CONSTRUCTION PLANS
FOR
THE OAKS AT OAKHURST

PLAN REVISION SUBMITTAL
MAY 2018

SDRSFR-2018-00019

SITE PLAN
THE OAKS AT OAKHURST

SHEET
C1.1

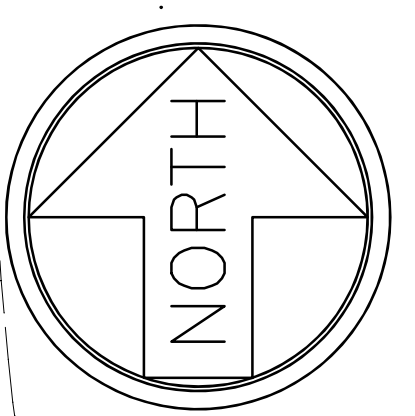
Please update your CDOT notes using the most up-to-date notes provided here:
INCLUDING PHONE NUMBERS
-Non-standard items (ie: pavers, irrigation systems, etc.) in the right-of-way require a Right-of-Way Encroachment Agreement with the Charlotte Department of Transportation/North Carolina Department of Transportation before installation. For City of Charlotte maintained streets, contact CDOT at (704) 336-3888.
-Any work within the City's R/W that requires closure of a sidewalk or travel lane must be approved by CDOT and will require a R/W Use Permit or R/W Lease depending upon the proposed duration of closure. These approvals are in addition to site approvals and should be coordinated with CDOT prior to construction.
Contractor shall contact CDOT at (704) 432-1562 at least 5 business days prior to beginning work for impacts less than 30 days. Contractor shall contact CDOT at (704) 336-8348 as soon as possible for impacts greater than 30 days. Every effort shall be made to construct improvements with minimal impact to drivers and pedestrians.
